**Federal Highway
Administration**

Mr. Edwin M. Wood's June 4 letter to Mr. Gerry L. Eller requested Federal Highway Administration's acceptance of your Narrow Quickchange Moveable Barrier as meeting the performance evaluation criteria set forth in National Cooperative Highway Research Program (NCHRP) Report 350 for a test level 3 (TL-3) barrier. To support this request, you included copies of a May 1997 report prepared by E-TECH Testing Services, Inc., entitled "NCHRP Report 350 Crash Test Results for the Narrow Quickchange Moveable Barrier" and a videotape of the two full-scale crash tests that were run.

Geometric and Safety Design Acceptance Letter BB-40

| TITLE: GOLDEN GATE VLB | MODEL: C970413 |

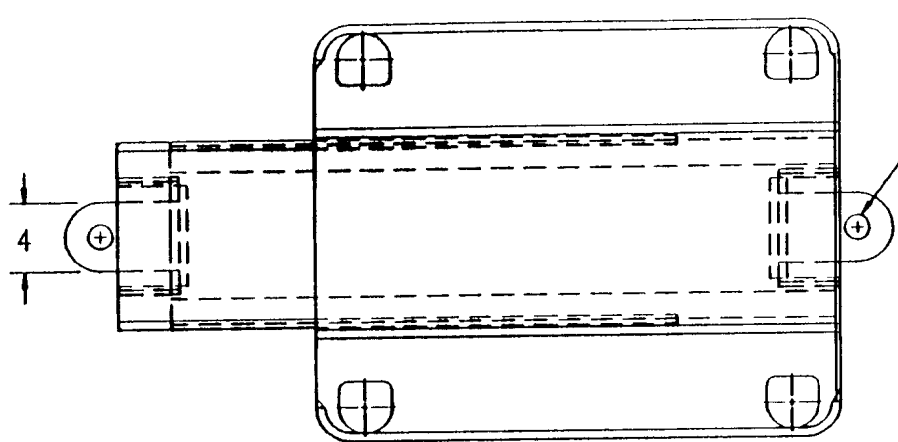
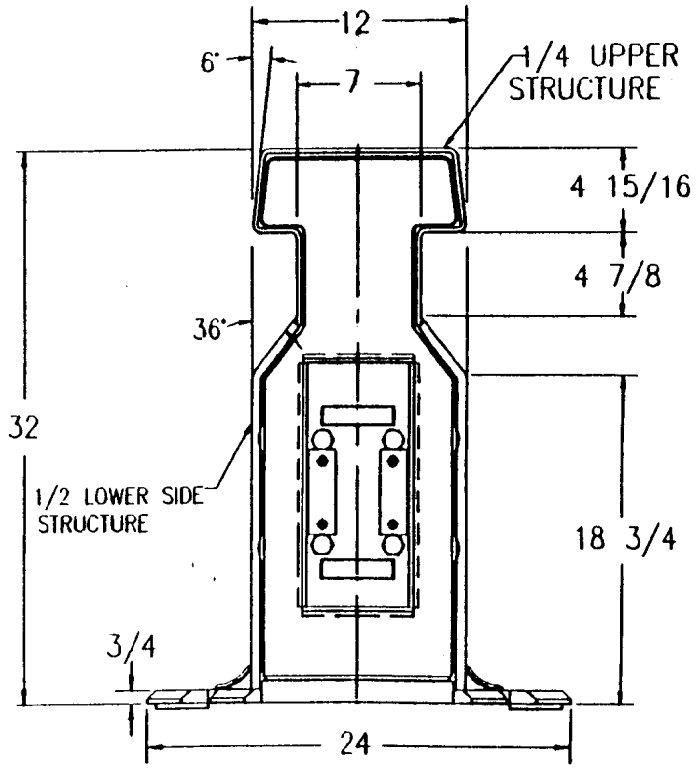
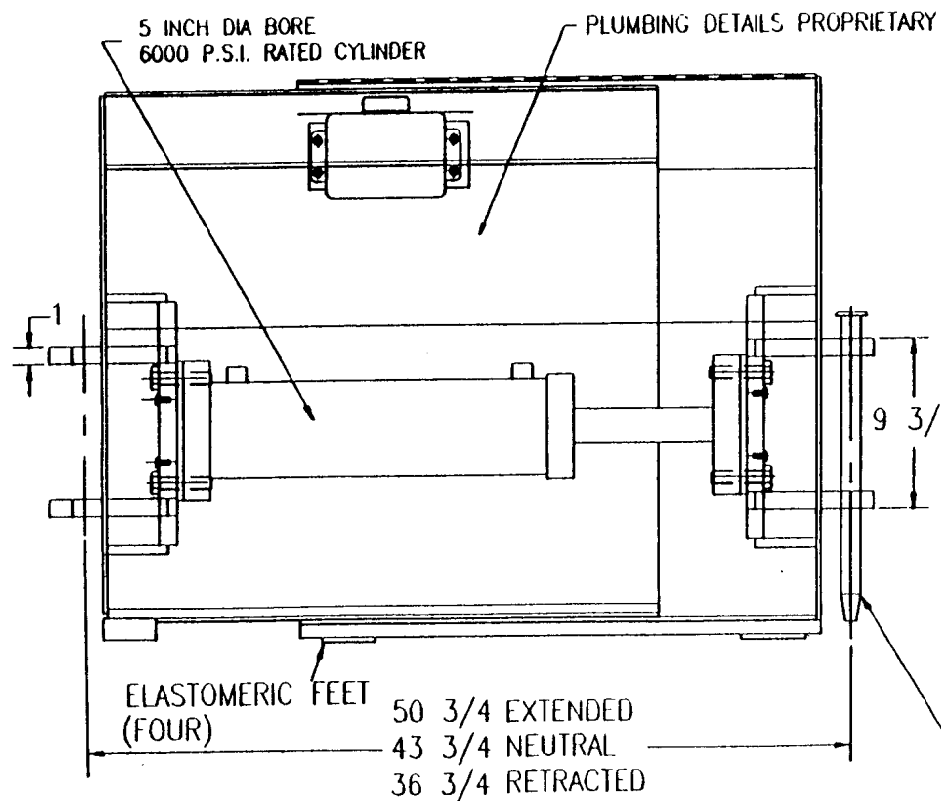
During our review, we noted that the VLB units were not impacted in either crash test. Since these units are not concrete-filled, we were concerned that they might constitute a "weak link" in the system, possibly causing a vehicle to crush the inner shell and snag on the exposed edge of the outer shell. In response to this concern and other questions, you provided additional information on July 1, followed on July 29 by a detailed structural analysis and information on a crash test you had previously run on a VLB incorporated into a standard (i.e., into a full-width Quickchange barrier) installation.

Figure 1. Summary of Results - Narrow QMB Test 04-0228-001

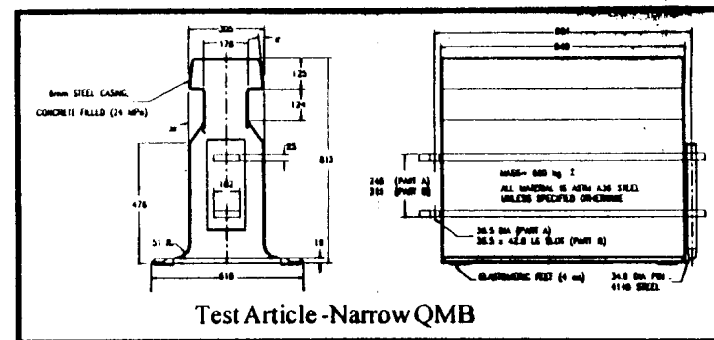
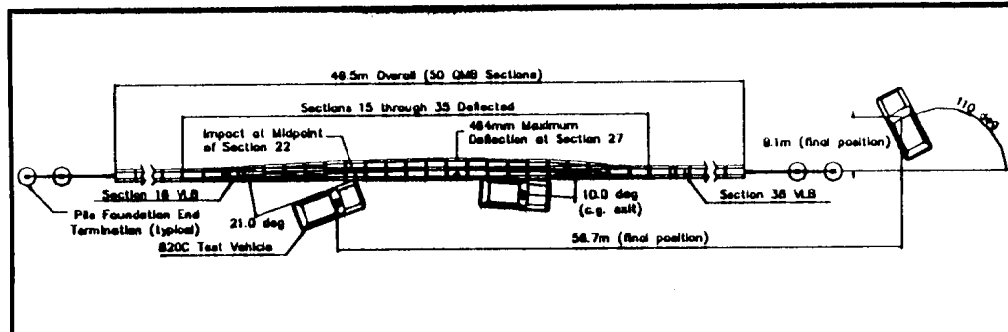
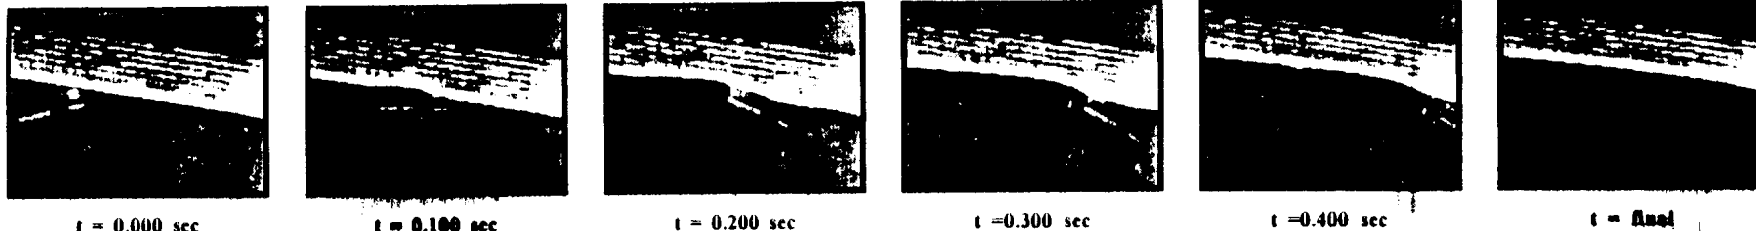
You conducted two crash tests on the Narrow Quickchange system. Test 3-10 was an 820-kg automobile impacting the barrier at nearly 107-km/h and a 21.0-degree impact angle. The recommended nominal impact speed and angle for this test are 100 km/h and 20 degrees, respectively. We noted that all evaluation criteria were met even though the impact severity (IS) exceeded the recommended upper limit of 40.0 kJ. The barrier deflected 464 mm. Test 3-11 was a 2000-kg pickup truck impacting the barrier at 98.2 km/h and 24.5 degrees. Although both of these variables are below the nominal values, the overall IS of 130.68 kJ falls within the lower limit suggested in the NCHRP Report 350, and again, all evaluation criteria were well within the acceptable ranges. Total barrier deflection for this test was 877 mm. Summary test data are shown on Enclosure 3.
